**STAFF REPORT TO THE
HEARINGS OFFICER
FOR THE CITY OF TIGARD, OREGON**

FILE NAME: MAIN STREET FANNO REDEVELOPMENT
CASE NOS.: Downtown Design Review (DDR) DDR2016-00003
Sensitive Lands Review (SLR) SLR2016-00006

REQUEST: The City of Tigard/City Center Development Agency requests administrative downtown development review for redevelopment of a 0.44 acre property (formerly the Saxony property) located east of Fanno Creek and north of Main Street. The proposal includes a 47,830 square foot, six-story mixed-use private development building with surface and tuck-under parking. A public space plaza is proposed adjacent to Fanno Creek. In addition to these improvements, the overall project includes demolition of existing buildings, remediation for contaminated soils, a lot line adjustment to correspond with the proposed public/private uses, and a development code amendment to increase the building height permitted in the Main Street-Center Sub-area from 45 feet to 80 feet. The lot line adjustment and development code amendment will be processed as separate reviews.

Exhibit 1: Site Plan

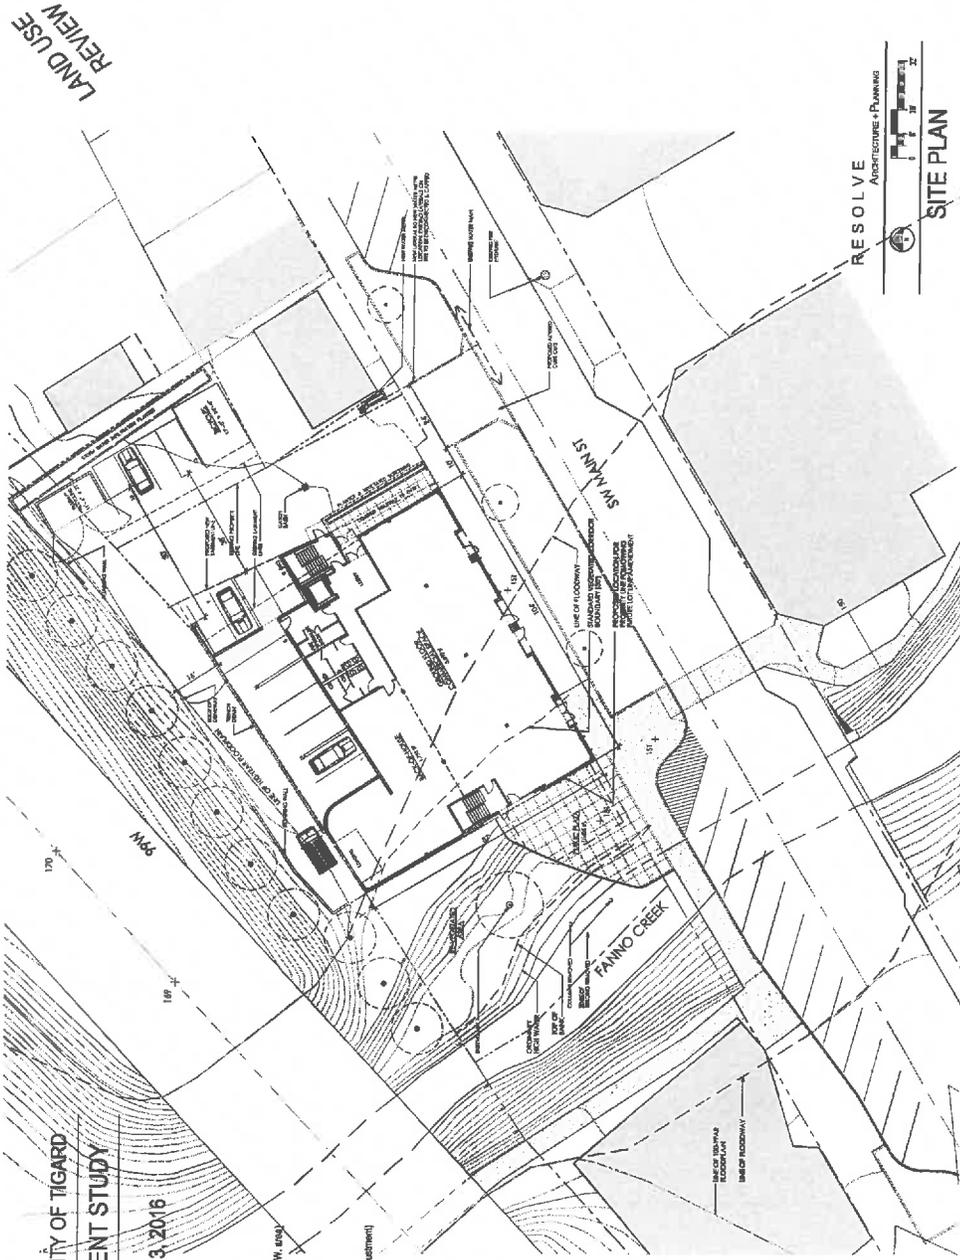
The proposed project is subject to the Main Street Sub-Area development standards. As shown on the Site Plan (Revised: August 3, 2016), and in the table above, the MU-CBD Development Standards are met except for the proposed building height. The applicant has applied for a development code amendment (DCA2016-00003) to allow six stories and, barring approval, will accept a three story height limit with the subject application. The proposed six floor building height cannot be approved at this time.

FINDING: As shown in the analysis above, the on-site parking standards are met, but the proposed height exceeds the allowed height and the roof top. Additionally, exterior mechanical equipment have not been shown on the plans. With the following conditions of approval the applicable Building and Site Development Standards can be met.

Five percent of 59 required spaces are 2.95 spaces. The site plan does not show motorcycle parking spaces on the Site Plan, so this exception does not apply.

Service facilities such as gas meters and air conditioners have not been shown on the Site Plan or elevation drawings. Plan check at the time of building plan review will ensure this standard is met.

6. The applicant shall submit revised building plans/elevations not exceeding three stories or 45 feet. However, provided a development code amendment (DCA2016-00003) permitting six stories is approved, the building may be up to six stories or 80 feet in height, provided it meets all other applicable standards.

7. The applicant shall submit revised plans showing location and screening materials of rooftop equipment and other mechanical equipment consistent with location and screening design standards in 18.610.020.B.3 & 4.

8. Prior to site work, the applicant shall submit written evidence that the property owners have entered into a binding agreement to share parking.
9. The applicant shall submit a bike parking plan consistent with the bike parking design standards in 18.765.050 for the number of bike parking spaces determined in Table 18.765.2.
